UNITED STATES PATENT AND TRADEMARK OFFICE

APPLICATION NO.	FILING DATE	FIRST NAMED INVENTOR	ATTORNEY DOCKET NO.	CONFIRMATION NO.
09/822,304	03/28/2001	Peter A. Kershaw	00P 7846 US 01	8077

**Office Action Summary**

**DETAILED ACTION**

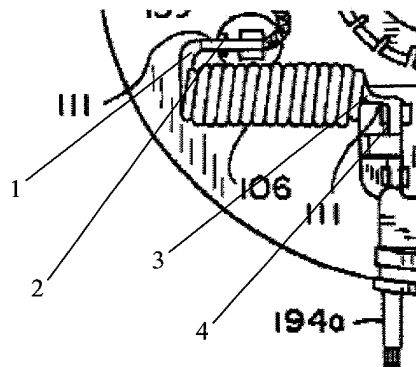
Horski et al. clearly teaches the construction of a sliding brush system with shape memory alloy element for two speed direct current motor comprising:

at least one choke comprising:

a portion wound about a coil axis to define a plurality of coils including two outermost coils (106),

an attaching structure (Figure 1) extending from each outermost coil and being generally transverse with respect to the coil axis and bent so as to extend away from each other at the second side of the brush card, including:

a first portion (2) extending transversely from an associated elongated end portion and generally along the common plane;

a second portion (1) extending downwardly and transversely with respect to the first portion;

a third portion (3) extending from the second portion so as to be generally parallel with the first portion; and

a fourth portion (4) bent to extend upwardly from the third portion to an associated outermost coil, the fourth portion being generally parallel with respect to the second portion,

an elongated end portion (111) disposed on a common plane, in spaced relation, extending from each attaching structure so as to be spaced from and generally parallel to the coil axis, the elongated end portions extending in opposite directions, from an attaching structure a distance substantially equal to a length of the portion wound about the axis;
